PLATE 1 - PLAN - PROFILE - F.A.S.
CLEARPRINT PAPER CO., S.F. CAL.
NO. 1000H-1

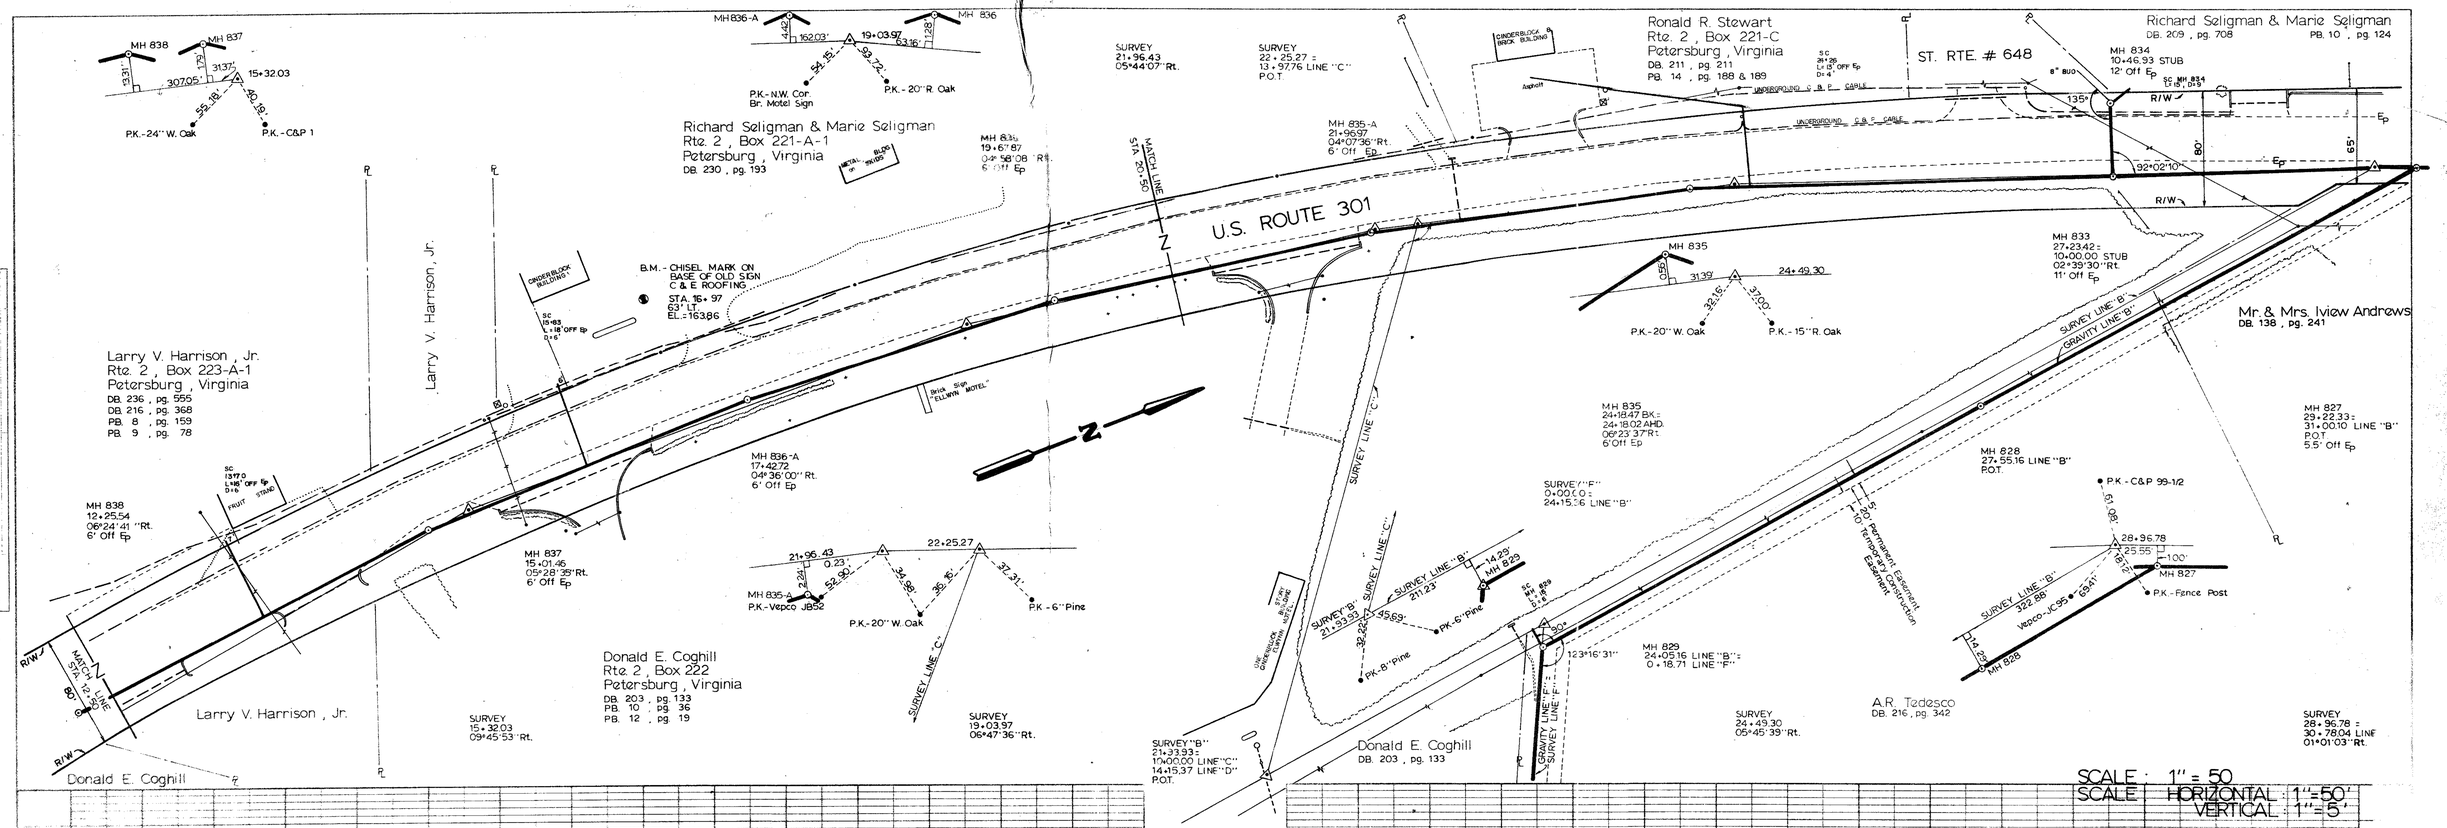
REVISED 11-15-79 - ADD DISTANCES OFF E.P. TO M/H LOCATIONS; ADD R/W WIDTH; CORRECT ℄ ALONG LINE "B" & ADD "MALONS" NAME

REVISED 12-05-79 - RELOCATE M/H 837 & 838
REVISED 05-19-80 - RELOCATE MAIN LINE FROM M/H 834 → 840 TO EAST SIDE OF RTE 301; RELOCATE & SHORTEN LINE "B" RELOCATE M/H 827

REVISED 11/07/80 - ADD M/H 835 & 836A
RELOCATE LINE "B" M/H 833 → M/H 833A
